BOM CHECK (automated - verify before acting)

ECONOMISER ASSEMBLY

DRG NO : EC-03-GA-001

BOM CHECK SUMMARY

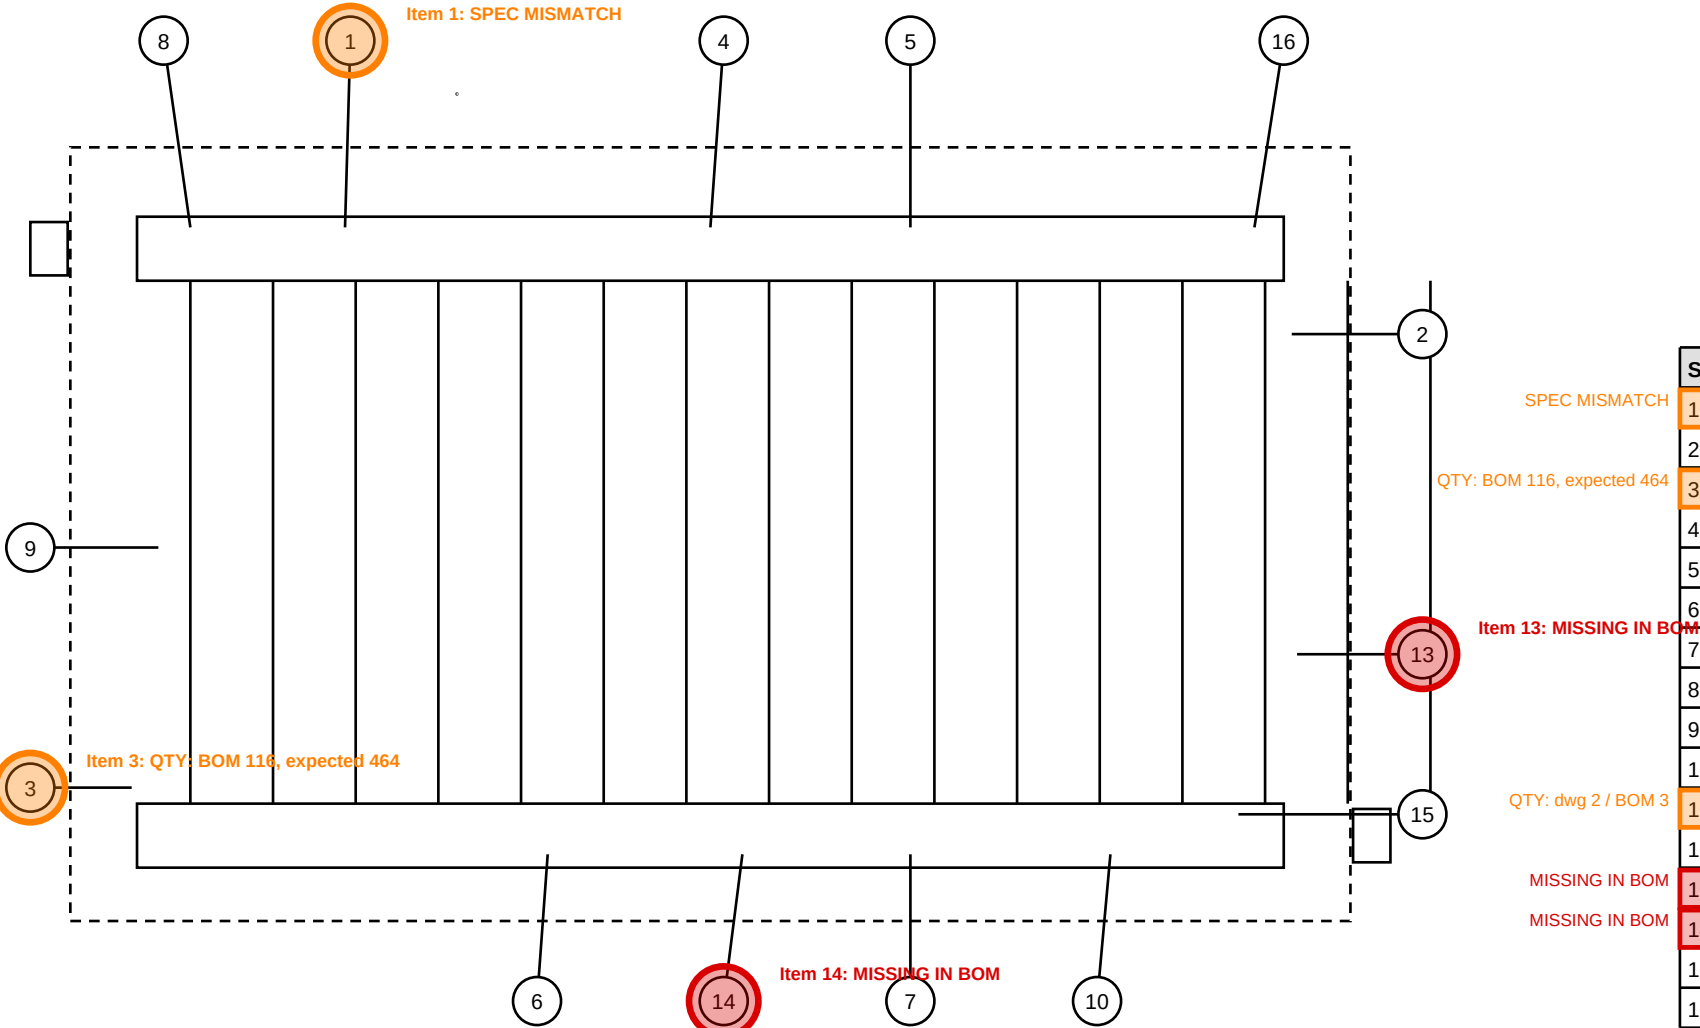
[RED] Item 13 'LIFTING LUG 16 THK' (qty 4) is on the drawing but has no BOM line
[RED] Item 14 'CASING PLATE 3 THK' (qty 23) is on the drawing but has no BOM line
[ORANGE] Item 1: specification mismatch - dimension: drawing ['8'] vs BOM ['10']
[ORANGE] Item 3: drawing note says qty is per bank, x4; BOM has 116 but total should be 464
[ORANGE] Item 11: quantity differs (drawing 2, BOM 3)
[YELLOW] BOM row 20 'Hand rail, 42 NB' has no matching item on the drawing (extra, or from another revision)
[BLUE] Suggestion (Welding consumables): the drawing notes imply it, but no matching line was found in the BOM
